**ADDENDUM NO. 1**  
**2025 ASPHALT OVERLAY PROJECT**  
**PROJECT #12525**

**ATTENTION ALL BIDDERS AND PLANHOLDERS:** You are hereby notified that the Bid and Contract Documents are amended as follows:

2025 ASPHALT OVERLAY

SHT. 23

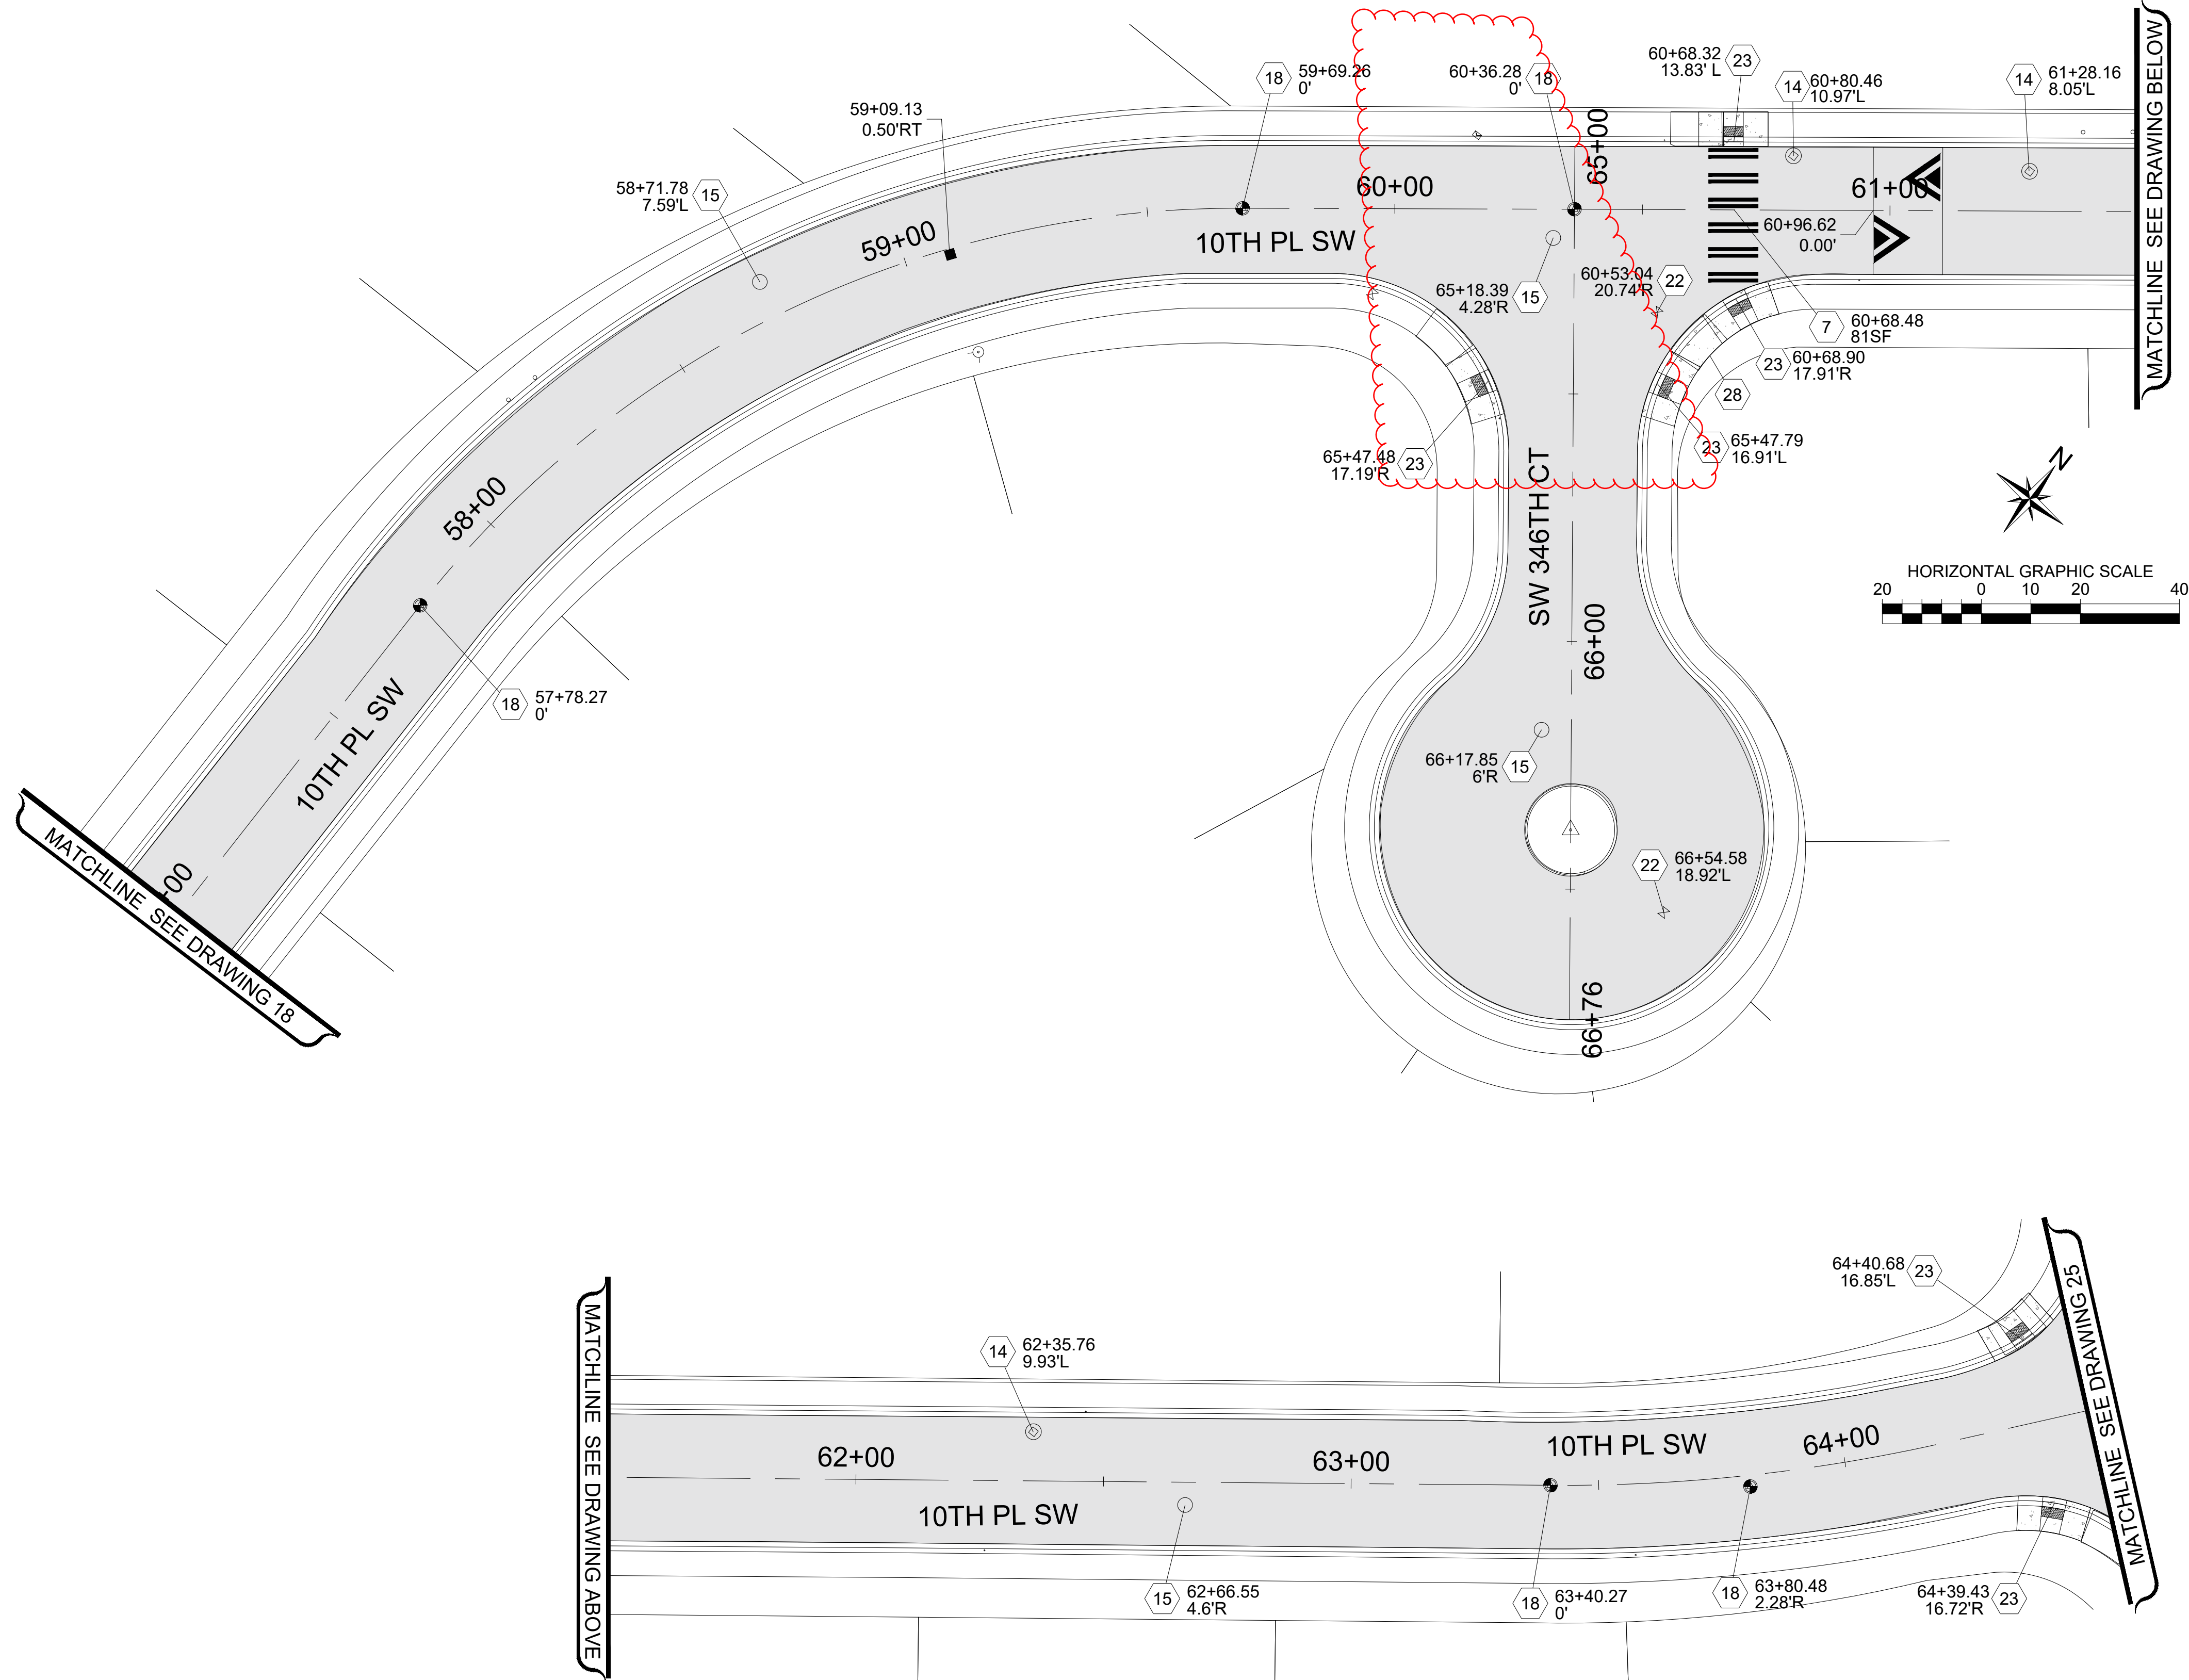
### **(1) Sheet 23 of 125 Plan Set:**

- Add Type B ramp callout to ramp on NW Corner

SHT. 24

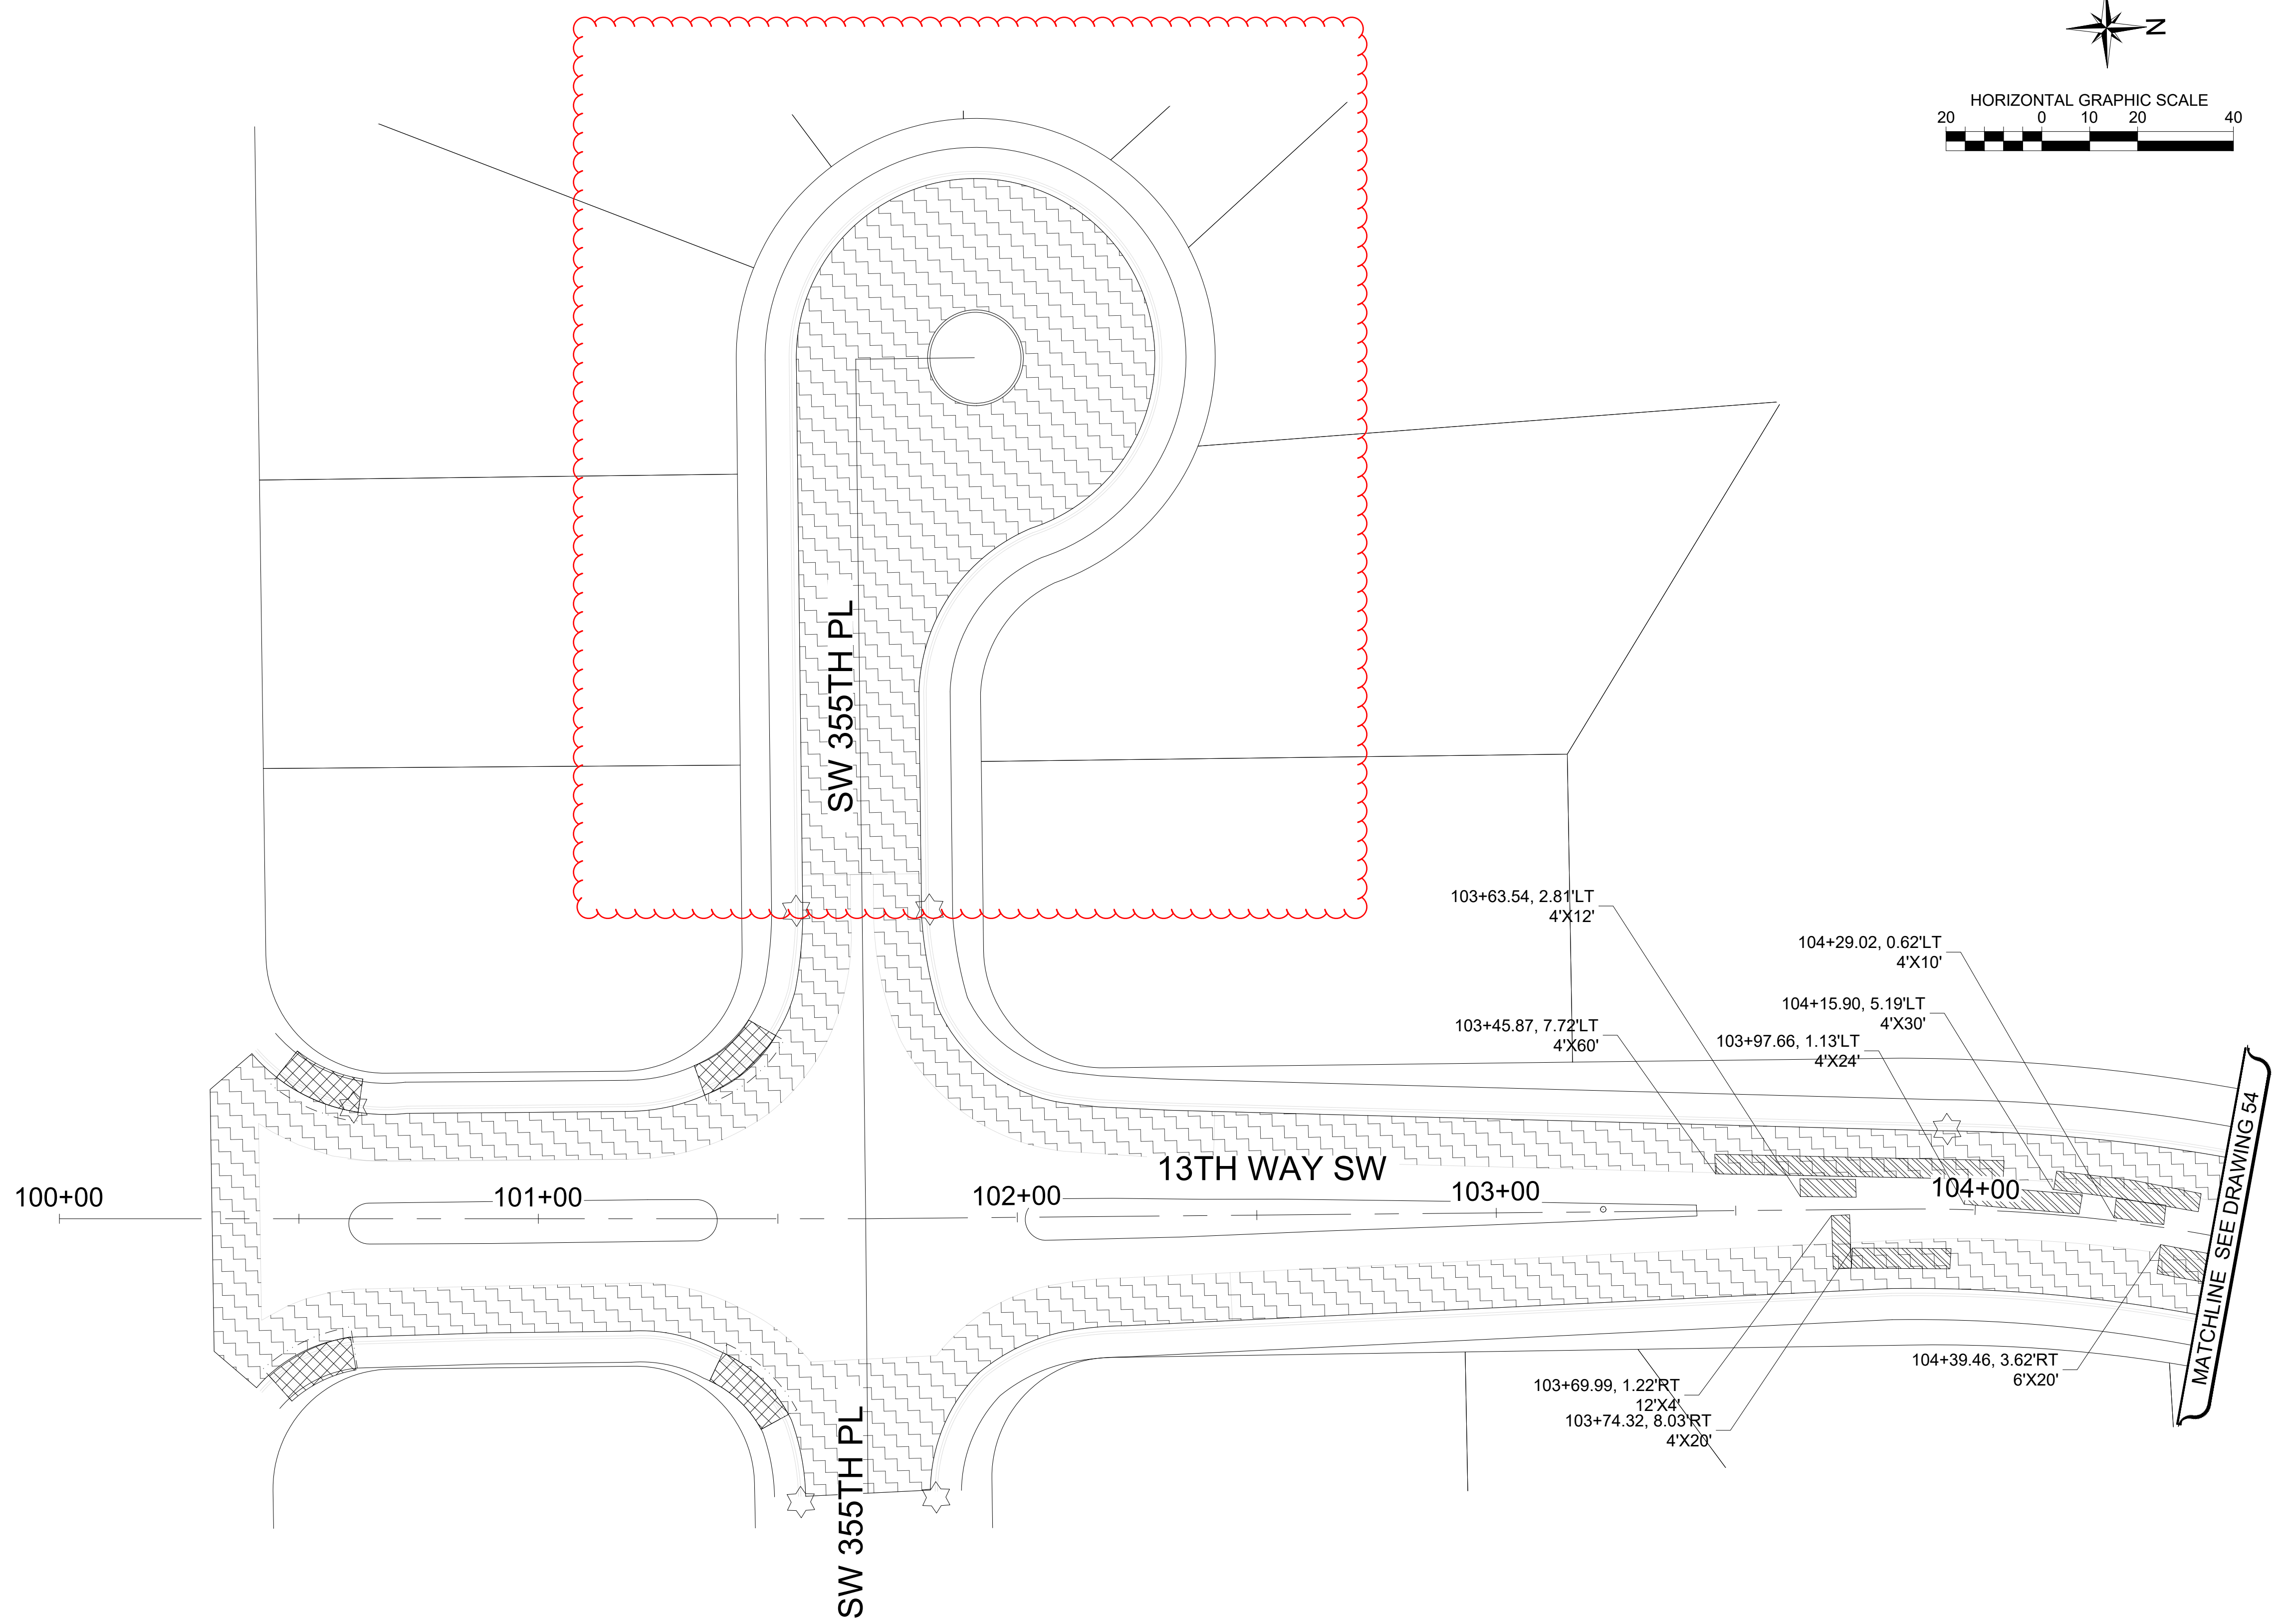
### **(2) Sheet 24 of 125 Plan Set:**

- Removed 2 crosswalks and removed 2 curb ramps

CITY PROJECT #:	12525
SHT.	53
OF	125

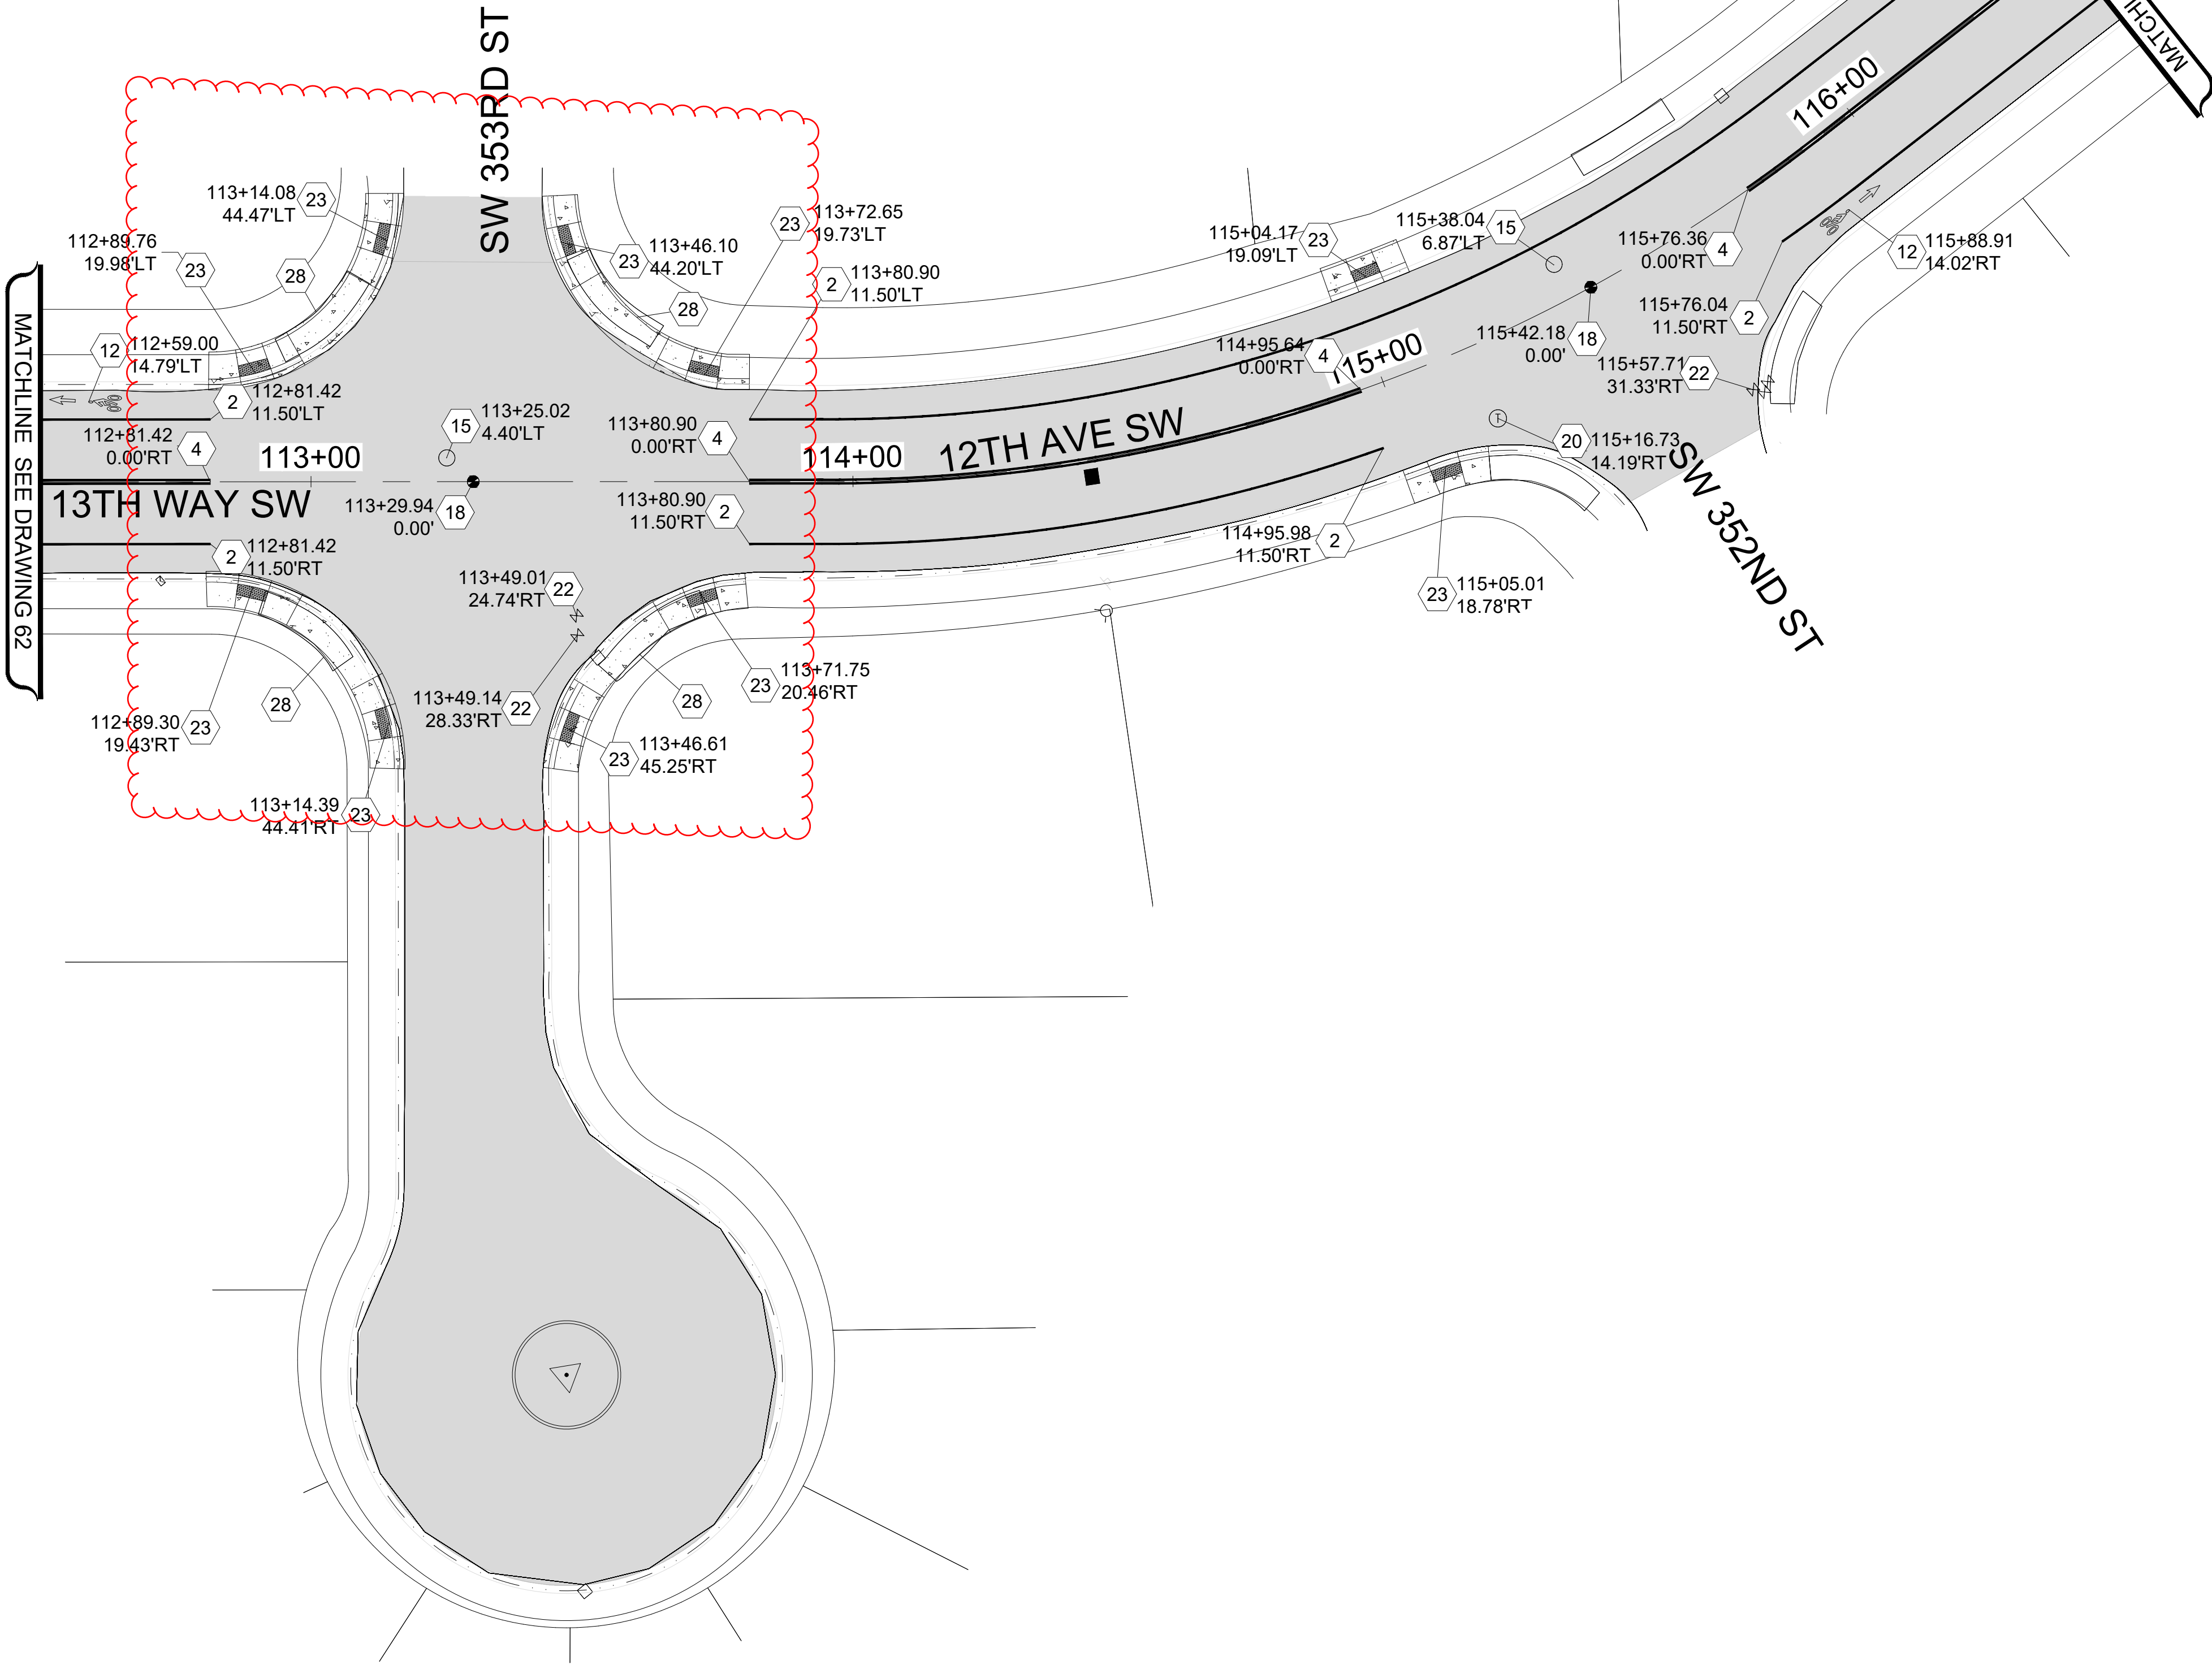
### **(3) Sheet 53 of 125 Plan Set:**

- Changed hatching for Cul-de-Sac to PLANING BITUMINOUS PAVEMENT.
